**Hazelnut Glen Subdivision**  
**Parcel No. H-0000-021-6900**  
**OO Land Holdings, LLC**  
**Case No. PZE-24-0013**

**BACKGROUND & SUMMARY OF REQUEST**

On March 28, 2024, Ray Kimball, Whipple Consulting, on behalf of OO Landing Holding, LLC, the owner, requested preliminary plat for a 126-lot Single-Family Residential (R-1) multi-phase subdivision to be known as Hazelnut Glen Subdivision. The property is located on one lot totaling 38.94 acres north of West Prairie Avenue, west of North Carrington Street, and south of West Honeysuckle/Bean Avenue.

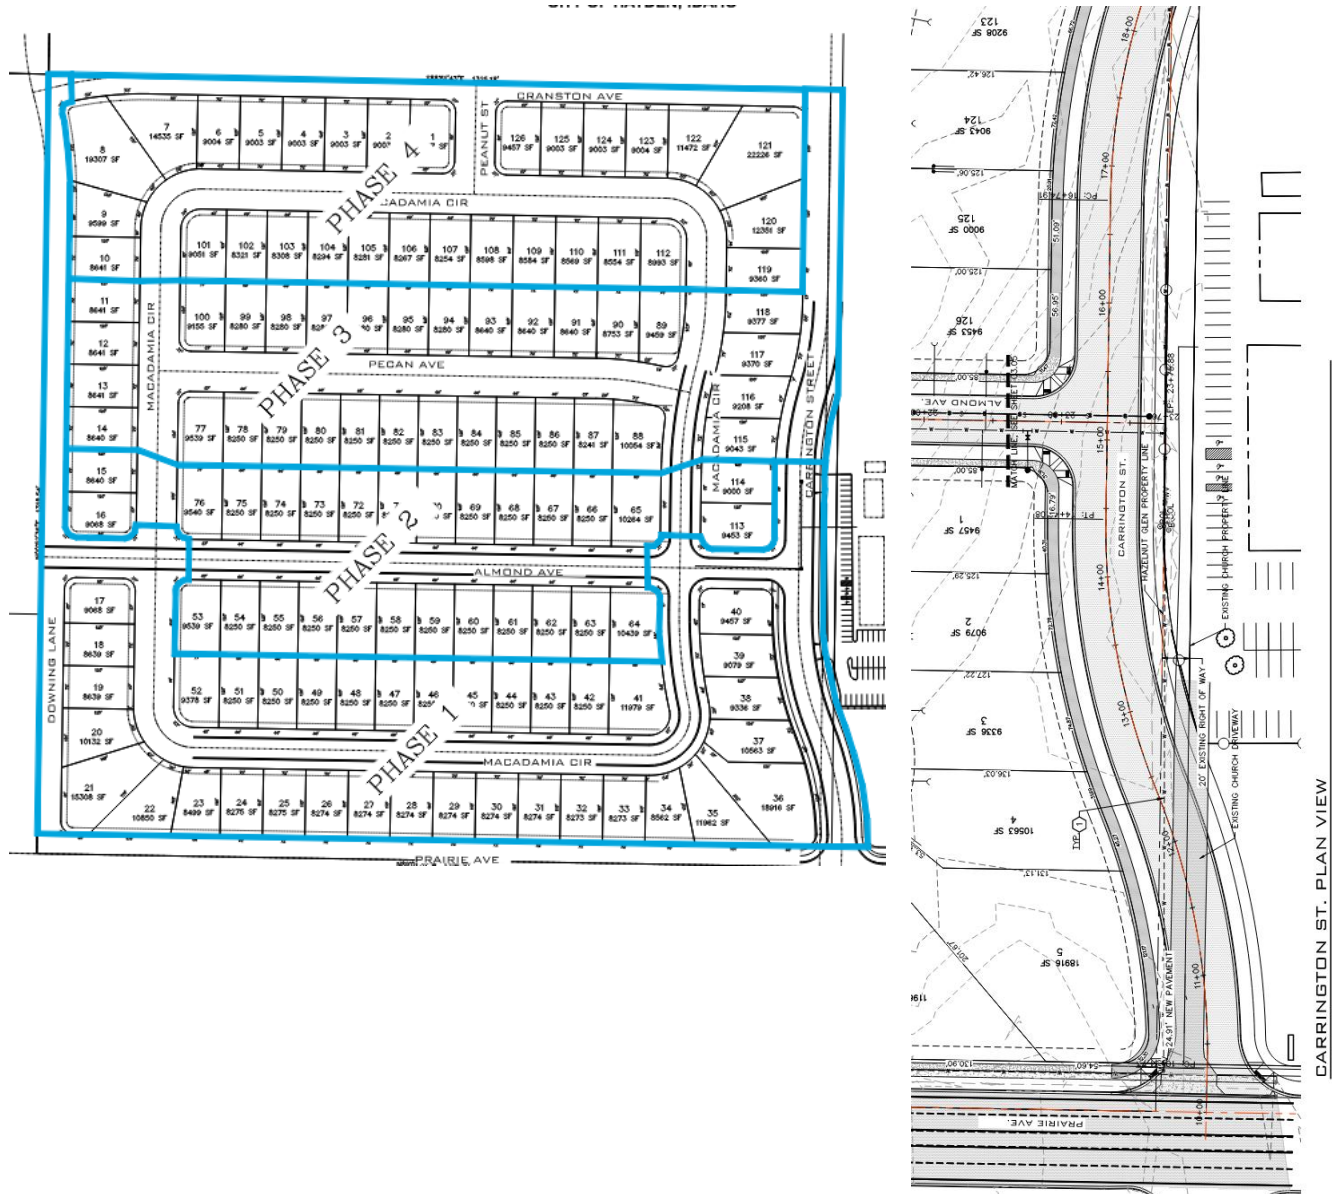
The code goes on to identify the need to create a homeowner's association to maintain the property within this greenbelt tract area as non-buildable landscaped area. The owner proposes this greenbelt area to be located per the proposed typical section shown below.

As proposed above, the portion of the greenbelt not within the right-of-way would be located not within a separate tract, but would be located within an easement in the rear yards of the properties along North Carrington Street. Greenways (greenbelts) are intended to allow for some flexibility in the location of the pedestrian path and the landscaping that would not necessarily mirror/parallel the roadway. The applicant has identified the path can meander through this area and the HOA will maintain the areas. Conversely, the City Council may allow for an alternative to meet this requirement whereby, the applicant shall provide the greenway/greenbelt to be located within a tract to be owned by the HOA, the lots along North Carrington Road may be less than 8,250 square feet, and the rear yard setback shall be measured from the right-of-way line but in no case shall be less than 15 feet to the rear property line. A fence shall be provided between the property line of the residential lots and the greenway easement or common area owned by the HOA.

As proposed, Carrington Street veers to the east at the southern intersection to Prairie Avenue onto the adjacent property. Today, Hayden has no infrastructure within this area that is below an acceptable level of service. Per the TIA, the Developer's project would have the result of an intersection (here) below a level of service D without a signal. Per City of Hayden, Post Falls Highway District, and City of Couer d'Alene this roadway shall be centered on the roadway of Carrington Street to the south of Prairie Avenue, as shown in close up to the right. Additionally, the Kootenai Metropolitan Planning Organization (KMPO) identifies Prairie Avenue as a Critical Arterial Corridor with no new individual access points and minimal street intersections. The Prairie Avenue rights-of-way are within the Post Falls Highway District's jurisdiction.

Carrington Street along the eastern boundary of the subject site shall be built to a C2 typical section and shall be constructed to a half width of 24' face of curb to road centerline (24' minimum paved width) to include pavement, curbs, 10' swales and Type IV landscaping, 10' path without consideration of greenway requirements is a minimum 45' half-width right of way. Greenway areas may overlap with required right-of-way typical sections, bike/pedestrian paths, and swale areas. Hayden City Code 12-6-1(B)(10) identifies the greenbelt tract as being a minimum of 30' wide measured from the back of curb, or if no curb, from the edge of pavement and meeting the standards of a Type III visual relief buffer in terms of deciduous versus evergreen ratios, tree spacing, and ground cover requirements.

## DEVELOPER PROPOSED PHASING PLAN

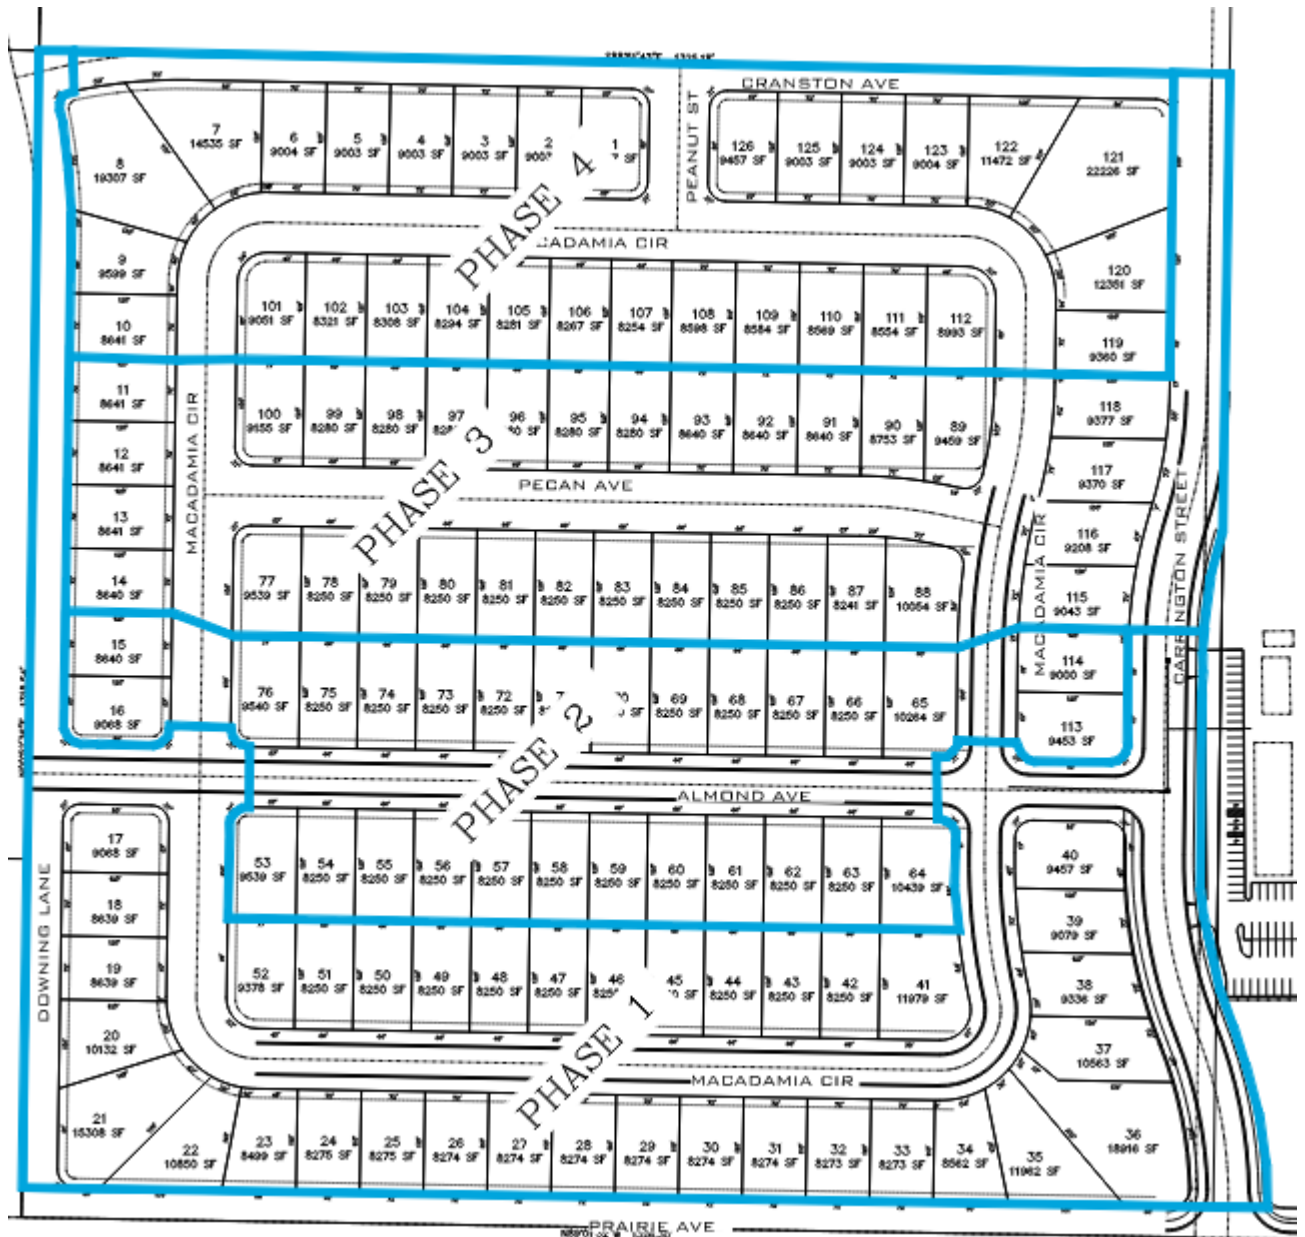
The phasing plan shown on page 7 identifies phases (1-4) and the number of lots within that phase. In section 3.6 Multiple Points of Access Required of the 2040 Access Management Policy it identifies the following:

Phased subdivisions are not required to develop in accordance with the increased numbers, but each phase must show that it can meet the standards of approval. As proposed, the first phase of the subdivision meets this condition; however, if the phases of construction occur in some other sequence, then it may be determined that revisions are required, subdivision layout may be affected which may cause the preliminary plat to be amended through the public hearing process. All required street improvements shall be in accordance with current City Standard Drawings and ADA compliance, including the proposed multi-modal pathway, pedestrian ramps, sidewalks, stormwater facilities, etc. Intersection spacing shall be in accordance with adopted access policies.
